MODEL BD-700-1A10 (BD-700)

ATA 52-31

**MODIFICATION – BAGGAGE DOOR –
 REPLACE BAGGAGE DOOR TRACK ROLLERS TO IMPROVE OPERATION**

SERVICE BULLETIN: 700-52-033 **ISSUE:** Basic **DATED:** Sep 15/2008

Baggage Door – Cam Roller Location
Figure 1

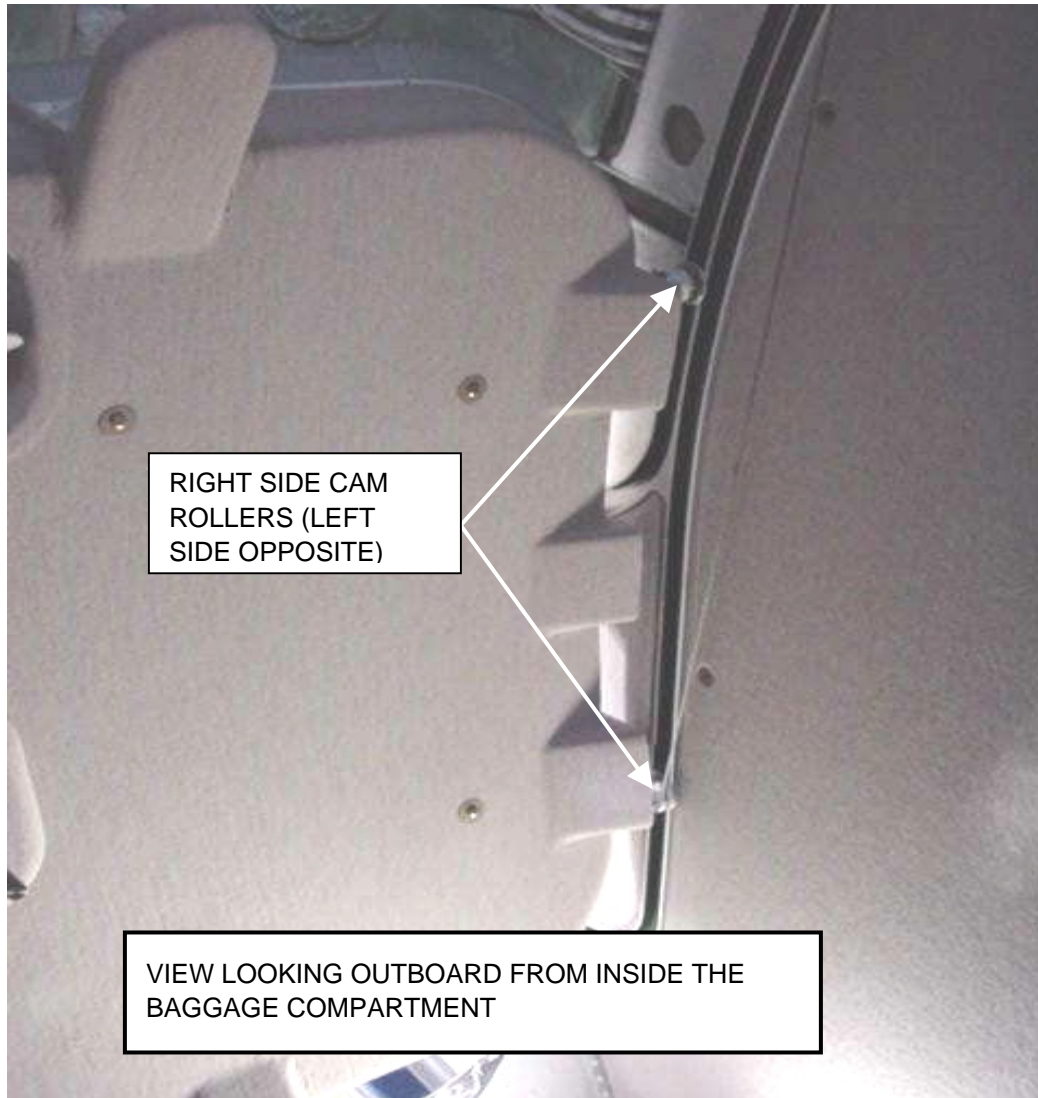
- (2) For each cam roller, do as follows before removal (refer to Figure 1 for cam roller location):

- (3) Remove and keep for reference the four cam rollers, Part No. NAS562-5R25. Refer to Figure 1 item 390 in the BD-700 AIPC, Chapter 52-31-01.

NOTE: Remove and keep the nuts (item 395), the jam nuts (item 415), the washers (item 420), the threaded sleeves (item 410) and the bumpers (item 405). Discard the cotter pins (item 400 not illustrated).

- (4) Install the four new cam rollers, Part No. GD322-3175-1 with kept hardware.

NOTES: 1. Use the recorded measurement from the kept cam rollers as reference to install and adjust the new cam rollers at each position on the door.

2. Torque the cam roller nuts 100 to 140 lbf-in (11.30 to 15.82 Nm) and safety with new cotter pins. Refer to TASK 20-50-00-400-801.

NOTE: If necessary, adjust the cam rollers with the jam nut(s) on the threaded sleeve(s) of the cam roller(s) and make sure that the distance between the cam rollers and the track flange with the door closed is between 0.020 and 0.025 inch (0.508 and 0.635 mm).
